Detailed Site Plan Brooks Drive Property

DSP-16037-01

STAFF REPORT

SUBJECT: Detailed Site Plan DSP-16037-01
Type 2 Tree Conservation Plan TCP2-005-2016-02
Brooks Drive Property

WAWA Monument Sign
(See Sign Package for Details)

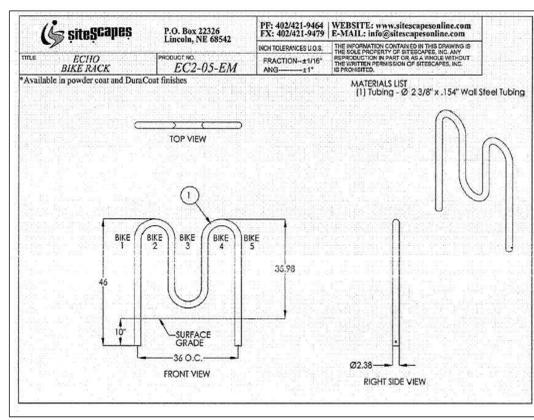
Two 67.4-square-foot building-mounted signs bearing the company's logo of blue, red, and yellow are provided for the project; one on the southern façade and one on the eastern façade of the building. A single ground-mounted 19-foot-tall freestanding sign is shown on the DSP at the intersection of Brooks Drive and Pennsylvania Avenue (MD 4). The sign is too tall and is out of character with the surrounding residential neighborhood. A detail of the sign has been provided on Sheet 7 of the plan set. Like the wall mounted-sign, the freestanding sign bears the company's logo of blue, red, and yellow. The ground-mounted freestanding sign shall, by condition of this approval, be reduced to no more than 15 feet.

- 1. Prior to certification, the applicant shall revise the plans as follows or provide the specified documentation:
 - a. Add an approval sheet to the detailed site plan set.
 - b. Show the height of the monument/pylon sign for Parcel 2 to be no more than 15 feet.
 - c. Provide a complete lighting plan showing photometrics to be reviewed for adequacy and approved by the Urban Design Section of the Development Review Division as designee of the Planning Board.

3 PROPOSED BIKE RACK
SCALE: NTS

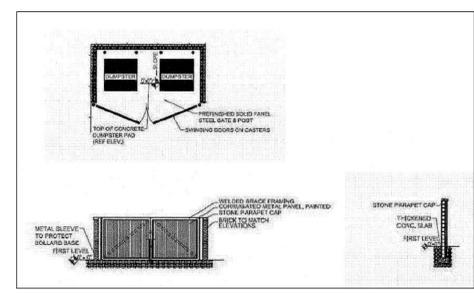
- e. **Trails**—In a memorandum dated April 6, 2020 (Ryan to Bossi), trails staff noted that a shared-use path and sidewalks are proposed as recommended by staff and the State Highway Administration, and that the plans are acceptable from the standpoint of pedestrian and bicycle transportation. One condition was recommended for the provision of inverted U style bicycle racks, versus the bike rack style provided with the DSP amendment.

- e. Revise the plan to provide two inverted U-style bicycle racks to replace the proposed bicycle racks on the submitted plans.
 - f. Revise the plans to remove all linework, labeling and notes for Parcels 2A and 2B, and revise notes and labels to indicate Parcel 2 as platted.

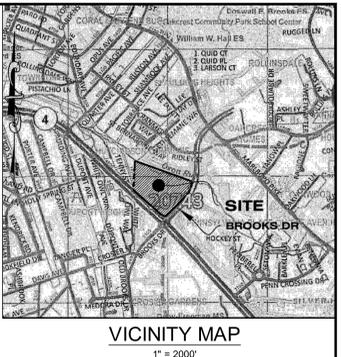
What are the limits of any easements? If there are any, label with Liber and Folio, size, etc.

Any activity in our easement would require a non-DR review. Grading, storm drains, etc.
